FSN Reference: FSN 22-004
FSCA Reference: FSCA 22-004

Re: Field Safety Notice for WiSE CRT Programmer Model 5100 Software Bug

WiSE CRT Programmer Model 5100 Software Bug

Figure 1: FOLLOW-UP screen with Optimize Targeting Button circled

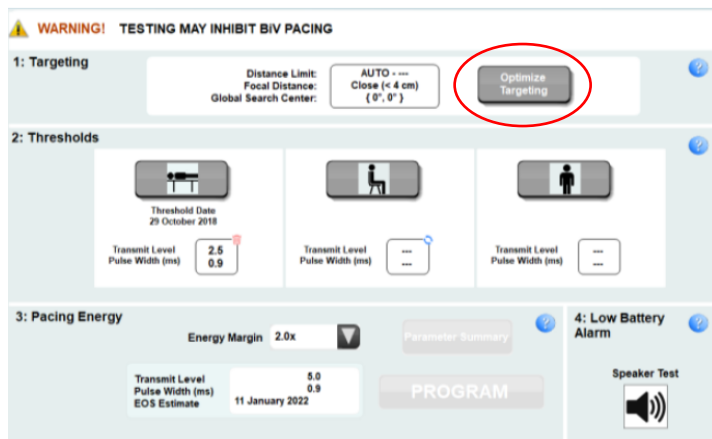
For devices programmed to utilize multiple targeting sensors, the Optimize Targeting mechanism in the FOLLOW-UP Screen (circled in Figure 1) **should not** be used as it will cause the currently active sensor to be the only enabled targeting sensor.

Do not use the FOLLOW-UP screen for patients that are programmed to utilize multiple targeting sensors.

Figure 4: MODE/OUTPUT screen

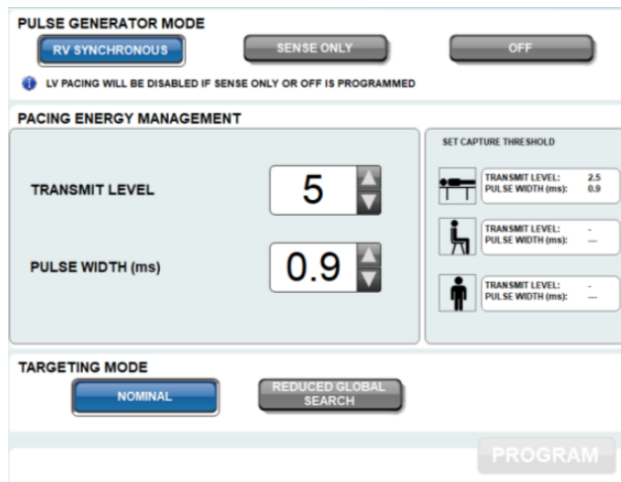
If multiple sensors are enabled, targeting optimization should be performed using the ACOUSTIC WINDOW screen and threshold testing using the MODE/OUTPUT screen shown in Figure 4 rather than FOLLOW-UP screen.
